SUBJECT: Forwards response to NRC 790918 request for info re steam generator waterhammer. Add info available in util 780103 ltr.

Re: Turkey Point Units 3 & 4
Docket Nos. 50-250 & 50-251
Waterhammer

ATTACHMENT 1

UNIT 3

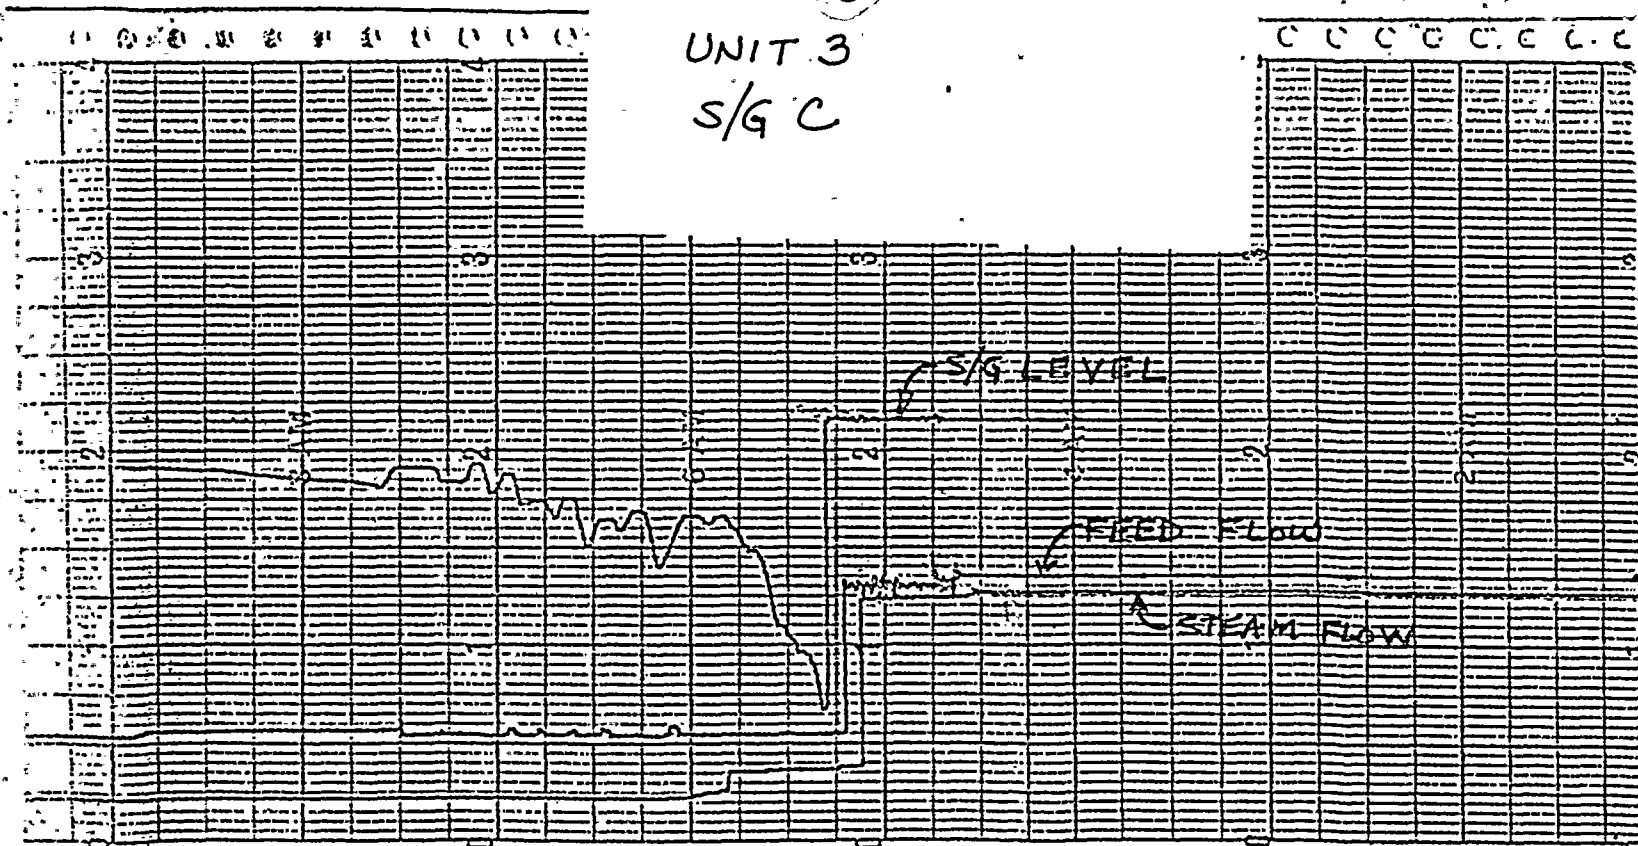
Item 1.1

Strip charts of steam generator water level, feedwater flow, and steam flow from representative reactor trip events are provided in Attachment 2. The charts show the behavior of steam generator water level as the result of a reactor trip from power levels greater than 30% of full power.
